GEORGETOWN-SCOTT COUNTY PLANNING COMMISSION

AGENDA

February 8, 2018

PRELIMINARY SUBDIVISION PLAT
BETTY YANCEY GRIFFITH TRUST PROPERTY
 CINCINNATI PIKE GEORGETOWN, KENTUCKY

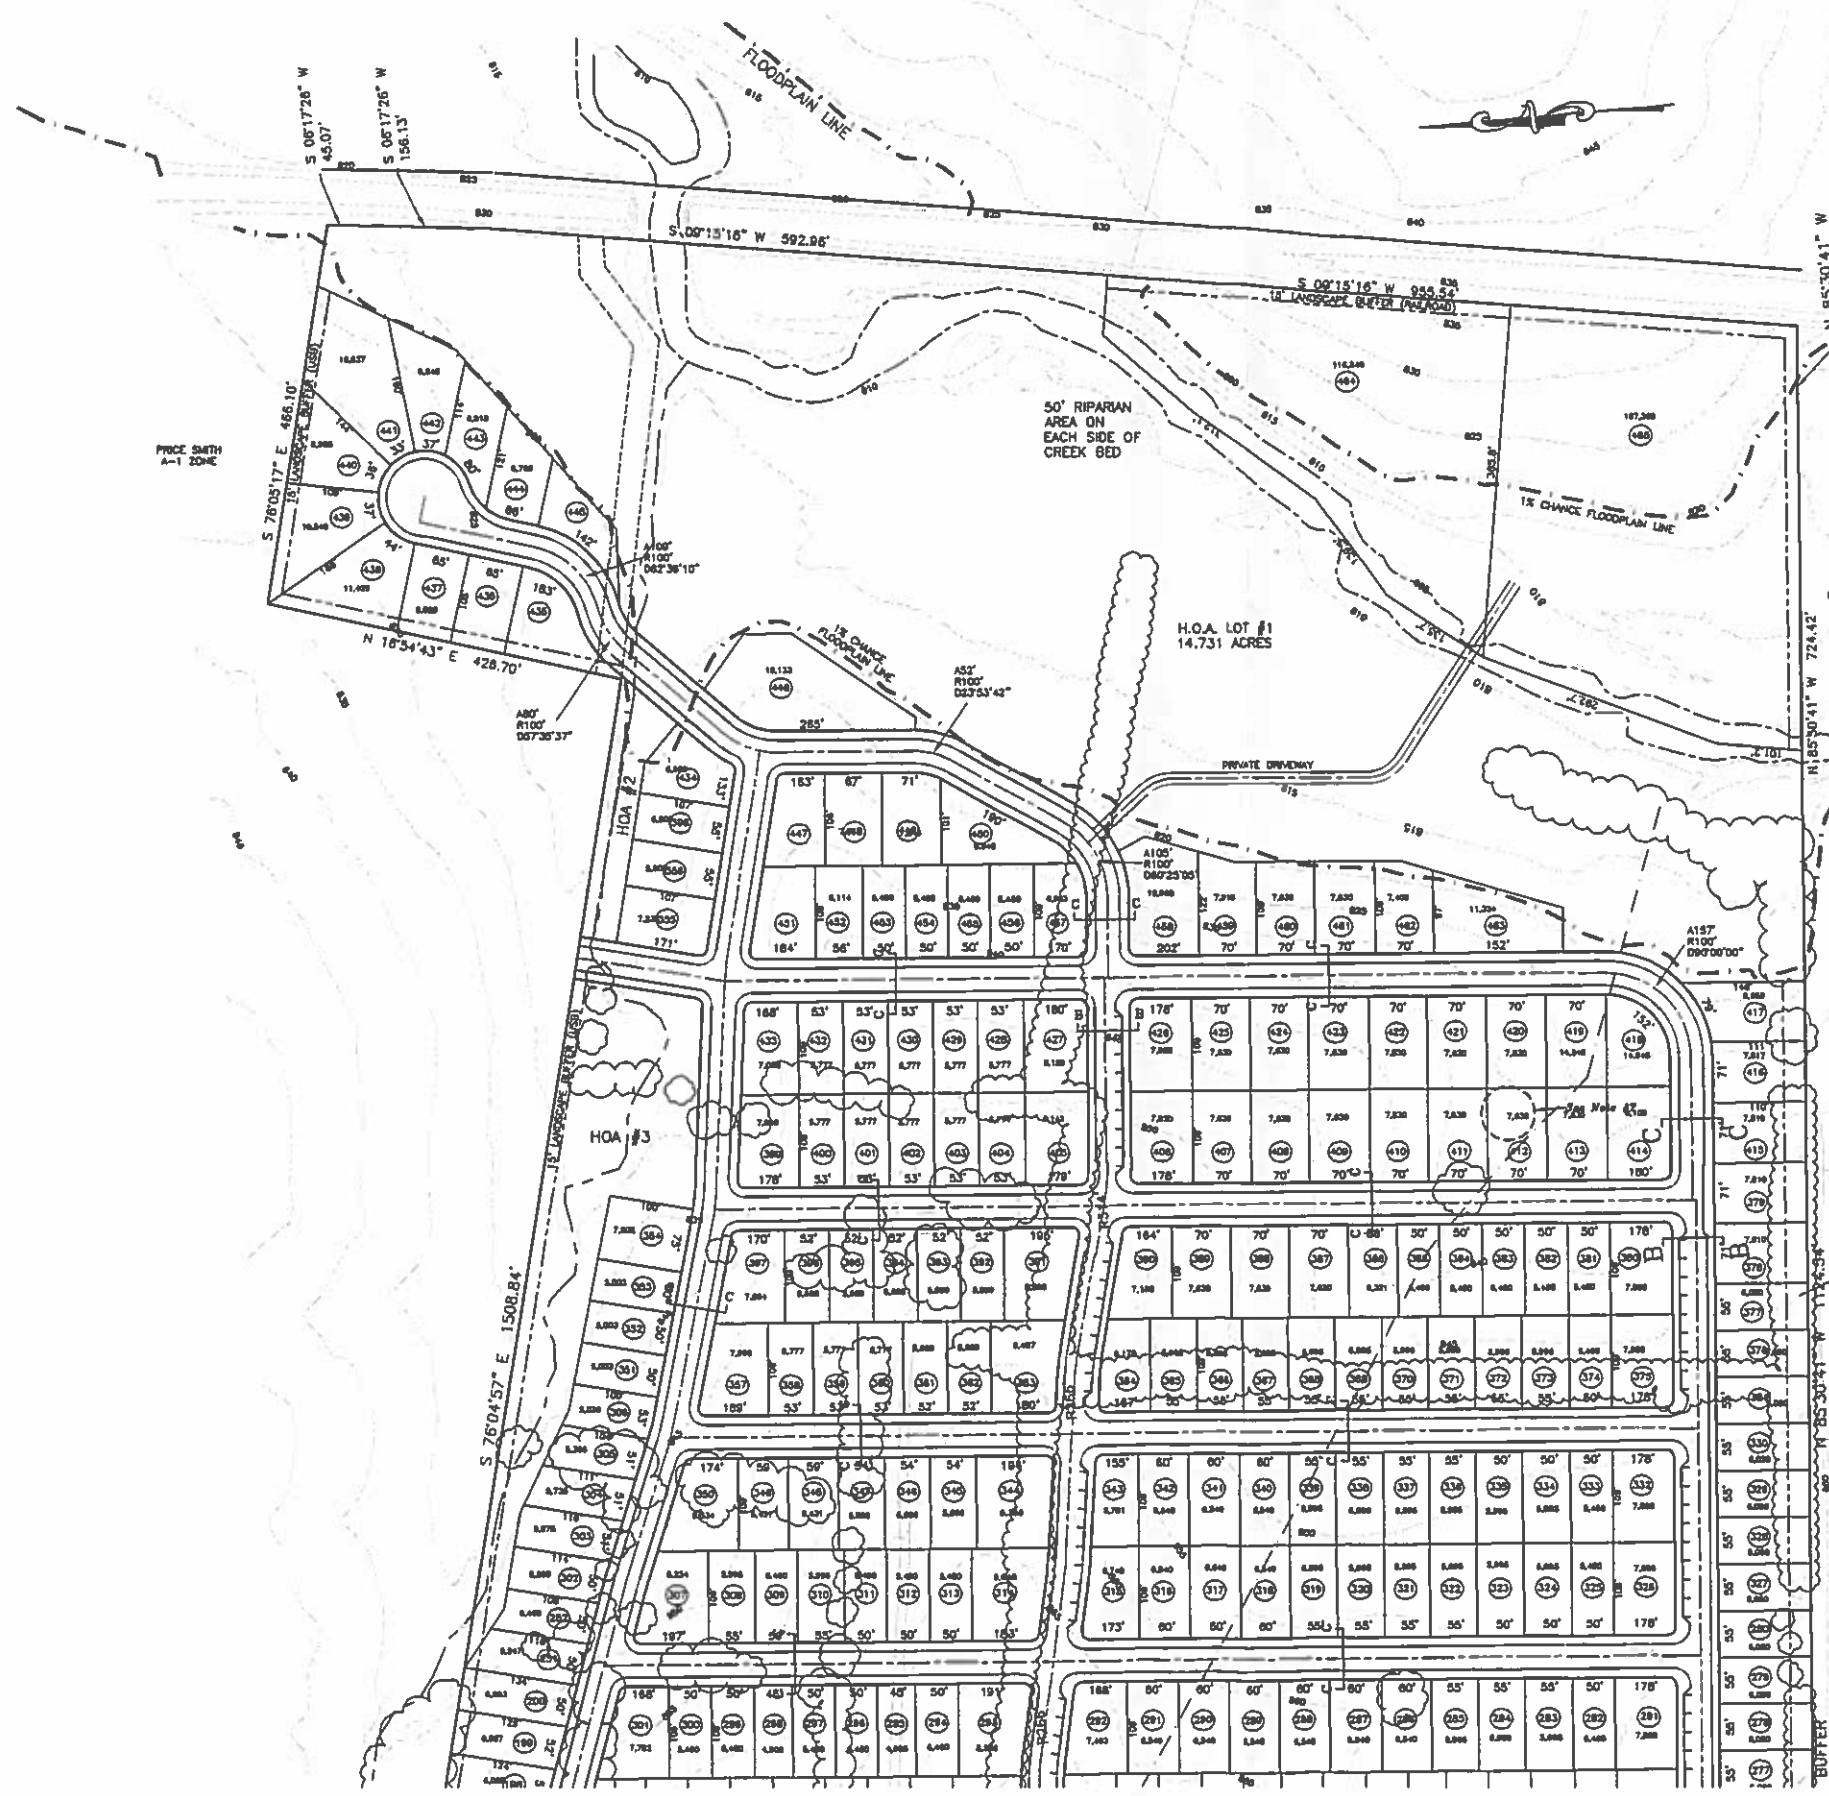
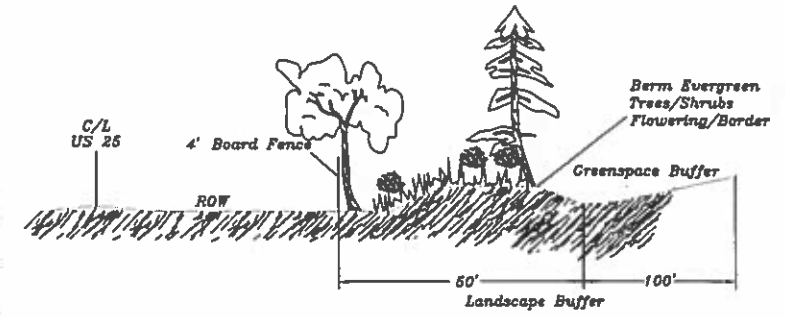
The number of 50' lots is drastically increased on the Preliminary Subdivision Plat from the Concept Plan. The majority of lots, nearly 70% are in the 50'-55' lot width range. In addition, the majority of lots are insufficiently deep to have usable back yard area. Especially along the perimeter of the site where there is a required 15' landscape buffer. The majority of lots are 110' deep. This may be sufficient to provide area for the principal structure, but leave little area for future expansion or attached decks or covered patios.

The proposed Preliminary Subdivision Plat statistics claim a minimum lot size of 5,235 square feet and an average lot size of 7500 square feet. However, after reviewing the submitted plan it appears there are numerous lots smaller than 5000 square feet.

this natural drainage area be better protected as it has historically flooded. Known karst features or potential karst features should be identified on the Preliminary Subdivision Plat.
